UNITED STATES PATENT AND TRADEMARK OFFICE

APPLICATION NO.	FILING DATE	FIRST NAMED INVENTOR	ATTORNEY DOCKET NO.	CONFIRMATION NO.
10/651,115	08/28/2003	Keith D. Mease	TN285	7863
7590	06/09/2006		EXAMINER	
Unisys Corporation Attn: Lise A. Rode Unisys Way, MS/E8-114 Blue Bell, PA 19424-0001			PAPE, ZACHARY	
			ART UNIT	PAPER NUMBER
			2835

## Office Action Summary

## DETAILED ACTION

Fig 1

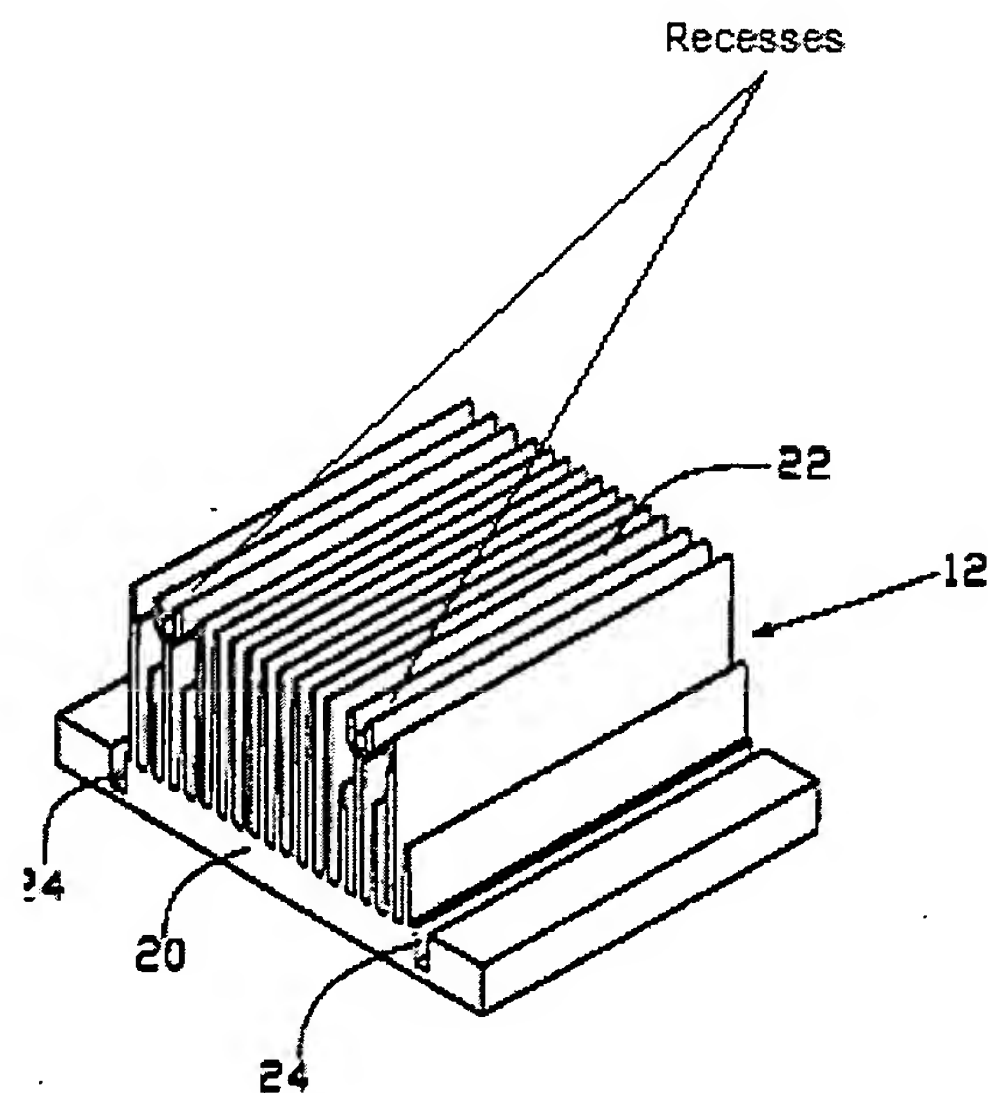
With respect to claim 1, Lo teaches a heat sink (10) configured to support an edge (74) of a circuit card (70), said heat sink comprising: a thermally conductive base (Generally 20); a plurality of thermally conductive heat dissipating fins (22) extending from said base; and one or more recesses (See Present office action Fig 1 below) at least partially defined by at least one of said fins (See Fig 1 below) the recesses having a depth smaller than the height of said fins, said one or more recesses being configured to support the edge of the circuit card.

With respect to claim 7, Lo further teaches that the recess is defined by a plurality of said fins (As illustrated in Fig 1 above).
